# MONITORING YEAR 4 ANNUAL REPORT

## HENRY FORK MITIGATION SITE

Catawba County, NC  
DEQ Contract No. 005782  
DMS Project No. 96306

RE: **Response to MY4 Draft Report Comments  
Henry Fork Mitigation Project**  
DMS Project # 96306  
Contract Number 005782  
RFP Number 16-005298  
Catawba River Basin – CU# 03050103 Expanded Service Area  
Catawba County, North Carolina

Monitoring Year 4 - 2019

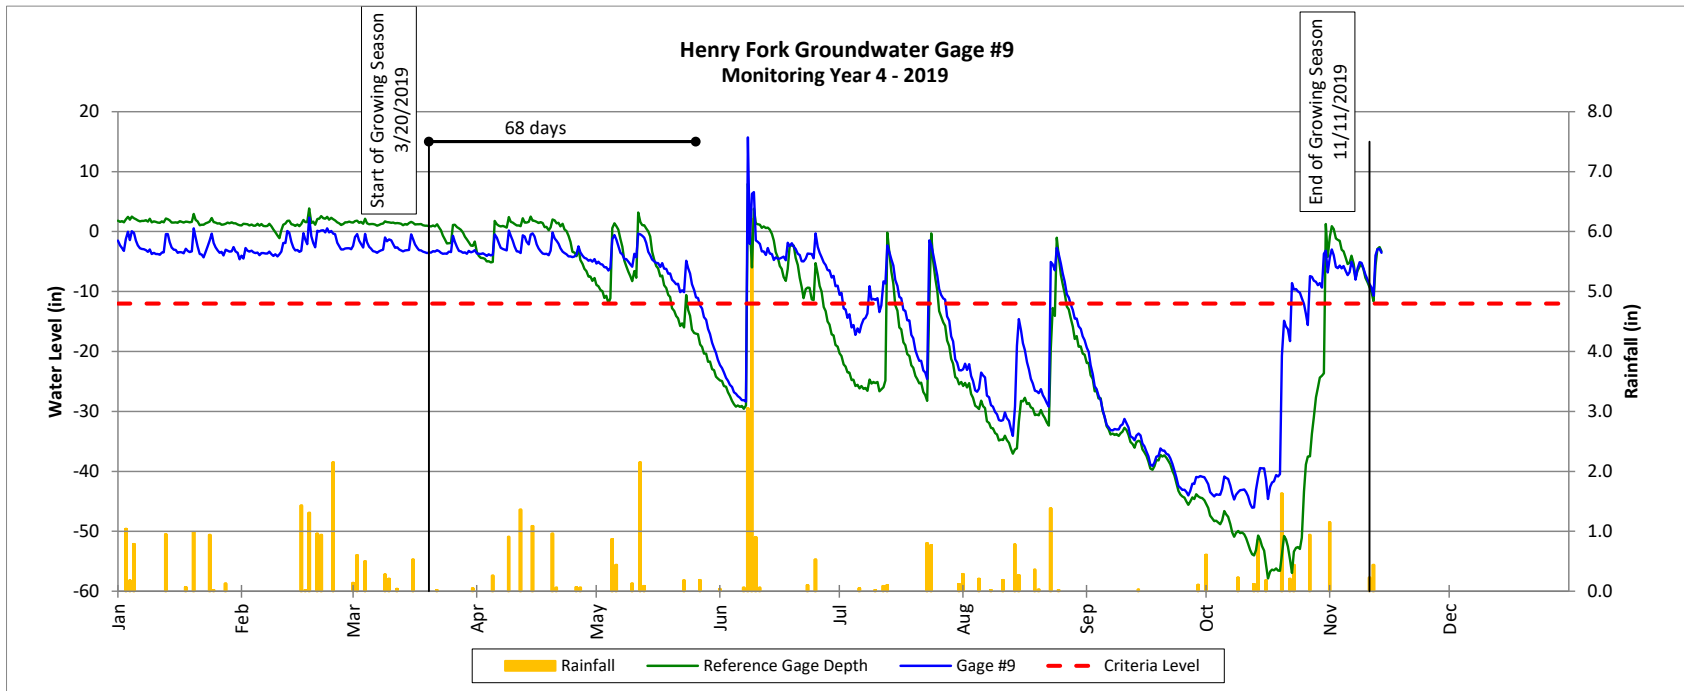
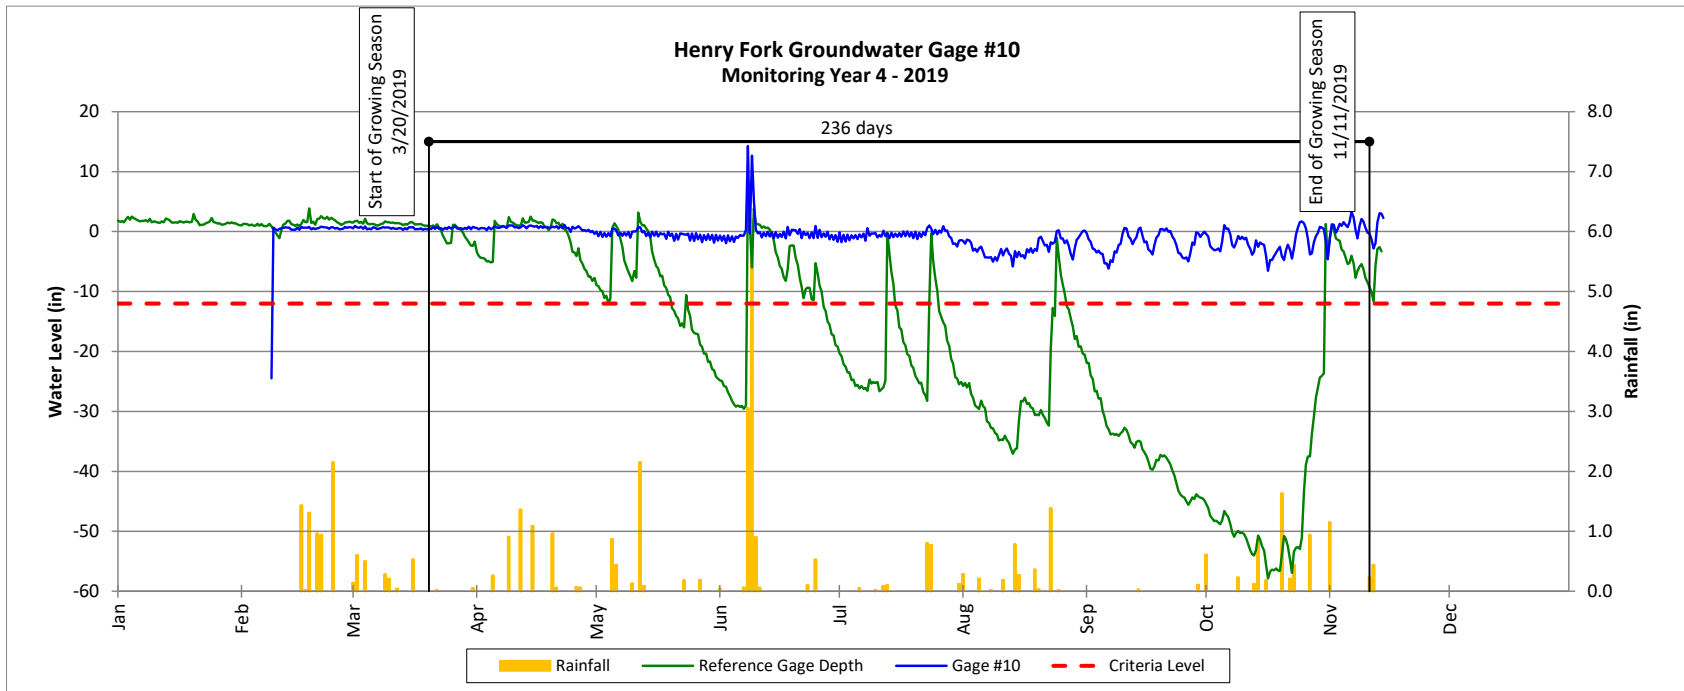
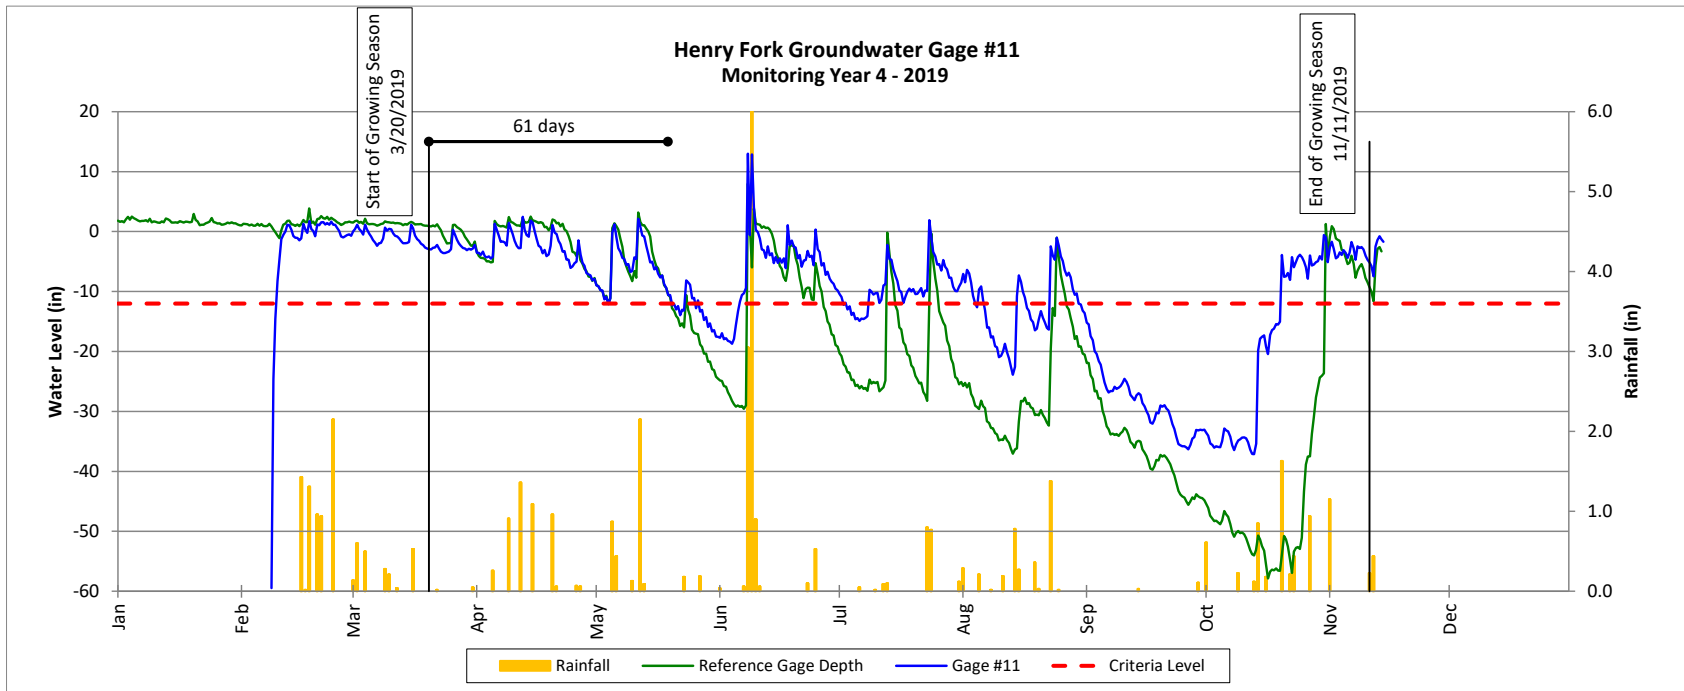
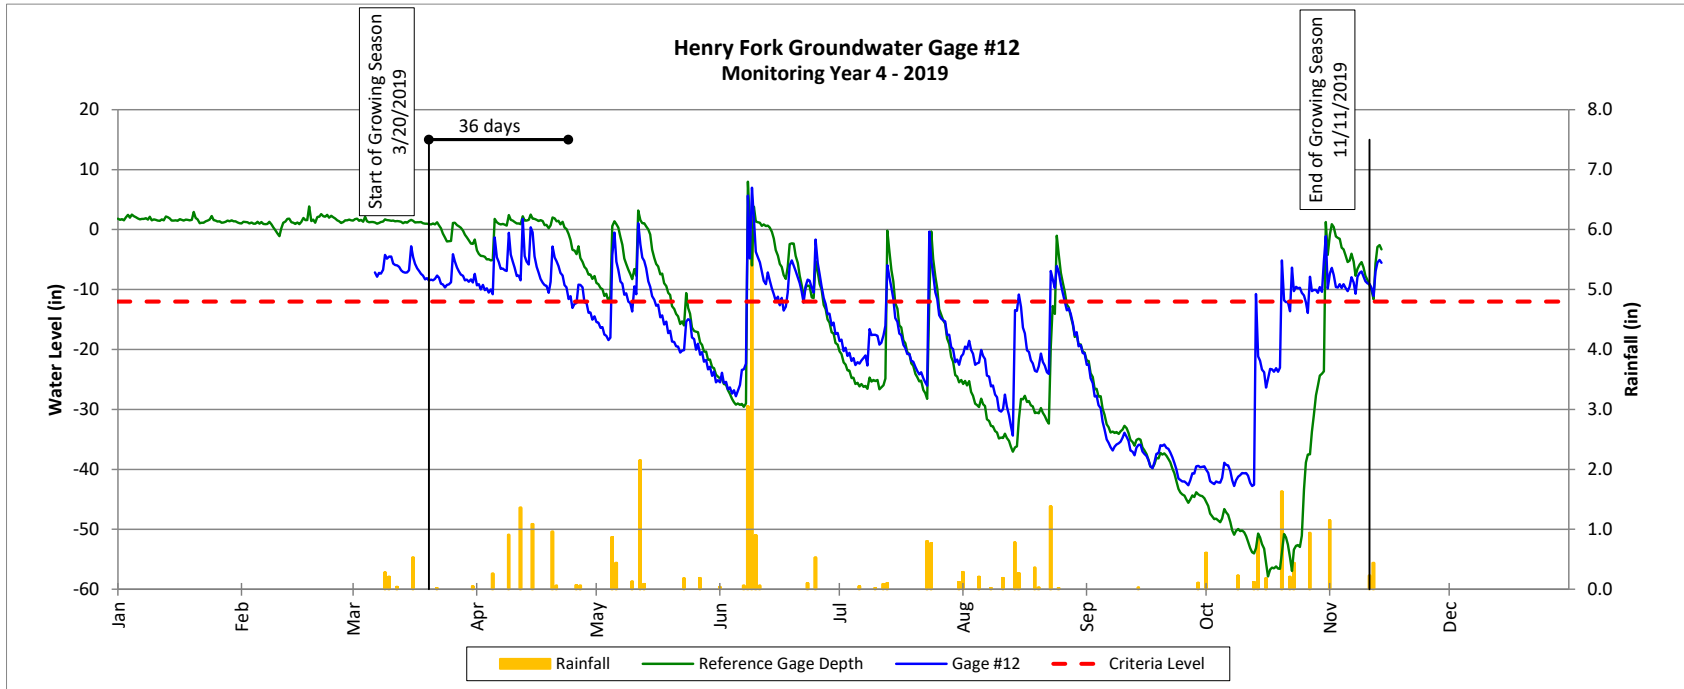
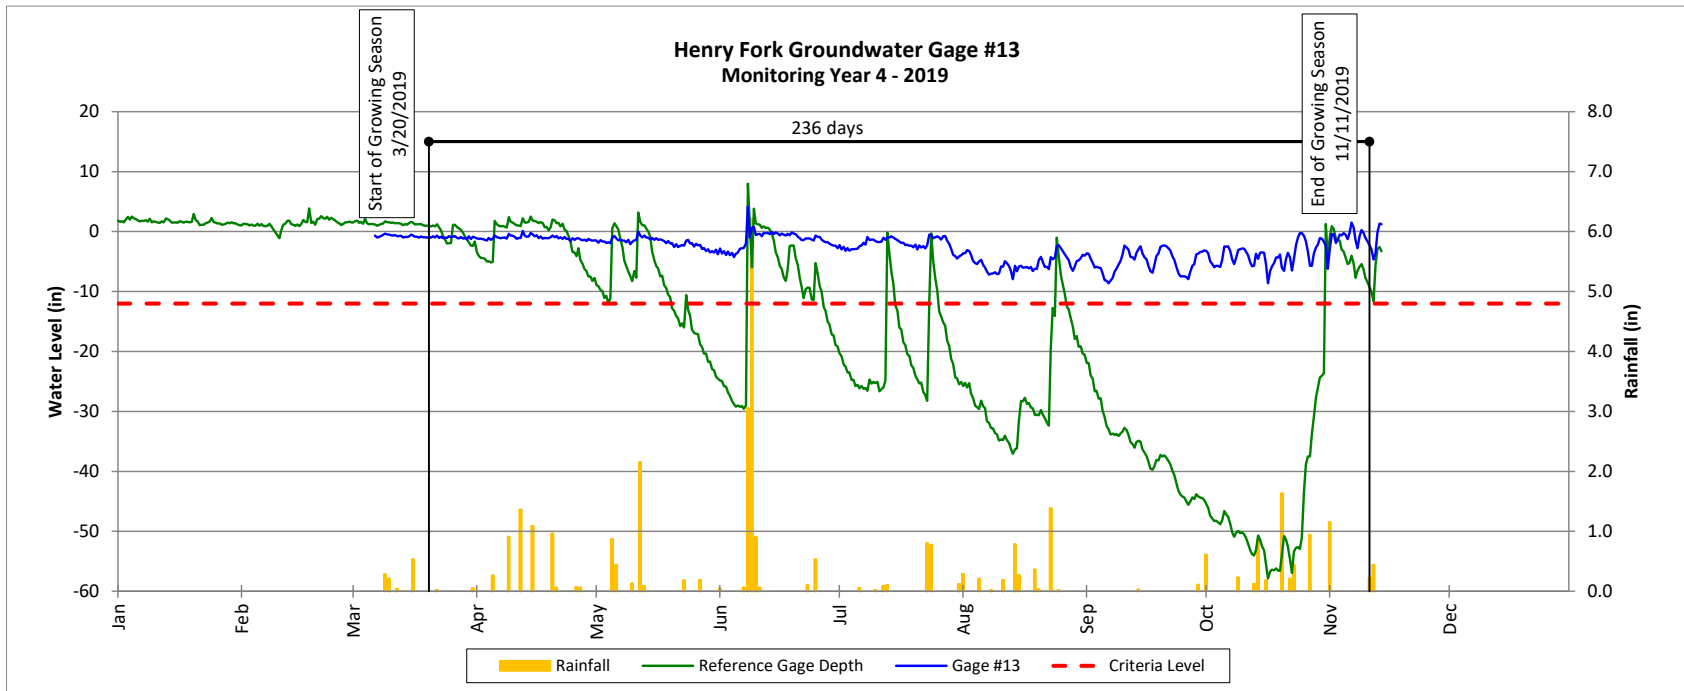
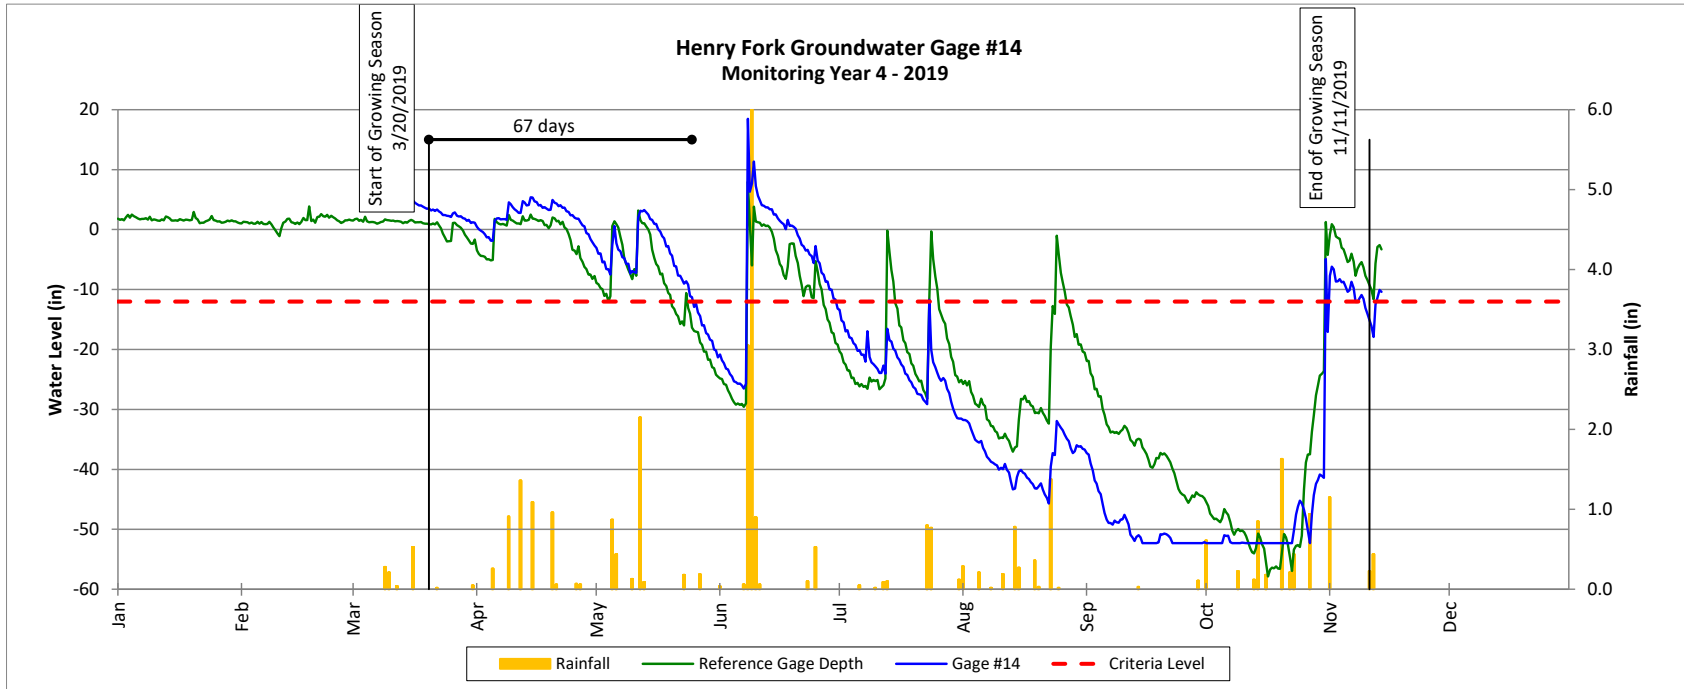
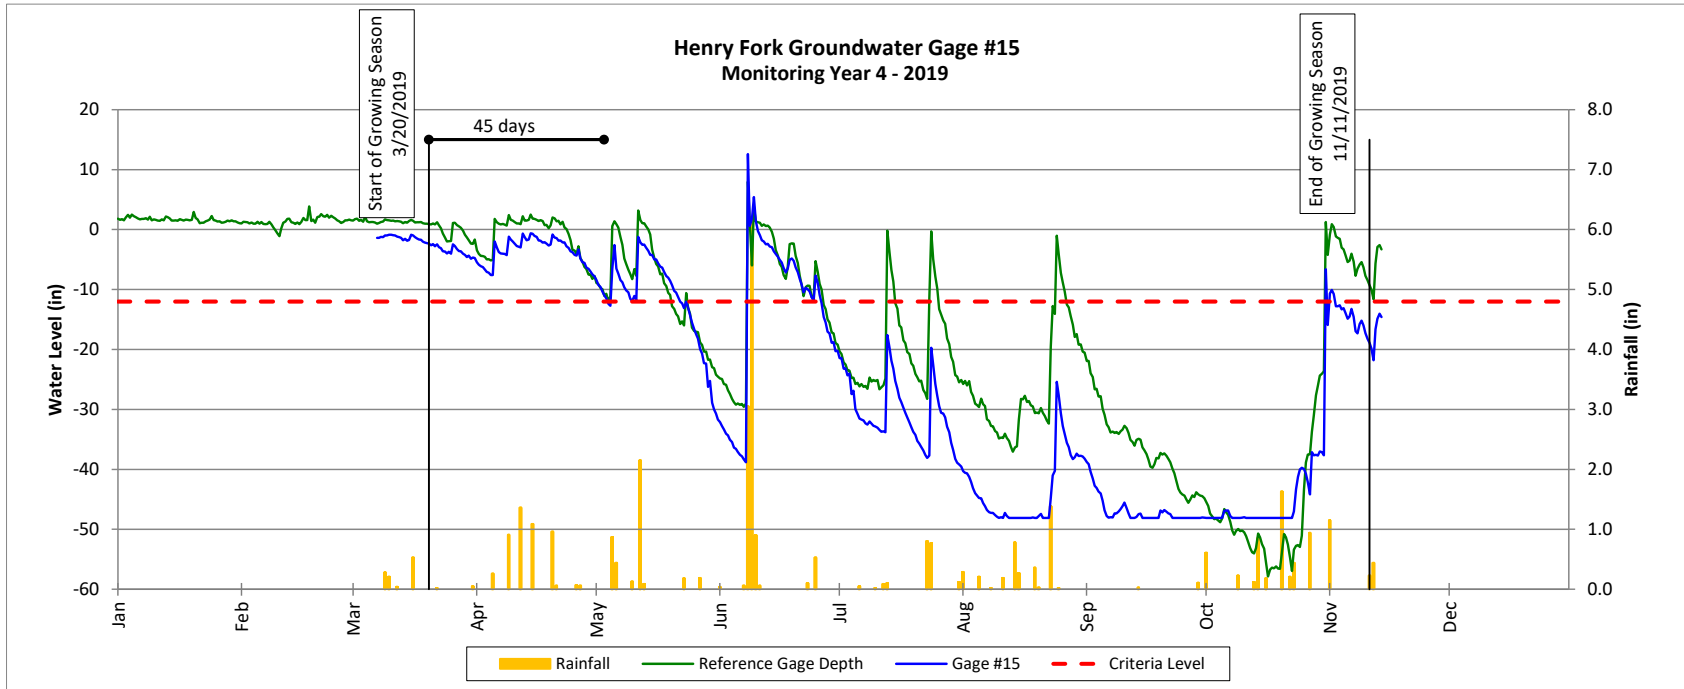
**DMS comment; For clarity, consider adding the consecutive day number for each gage on the groundwater gage plots instead of using the currently shown 20 day bar. The gage 8 plot shows 19 days which corresponds to the consecutive days for that gage. All the other gages use the 20 day bar.**

**The 20 day bar adds some confusion to the plots without a description of what it corresponds too (8.5% of the growing season).**

*Wildlands response; For clarity, the number of consecutive days is now shown instead of the 20 day bar on all groundwater gage plots.*
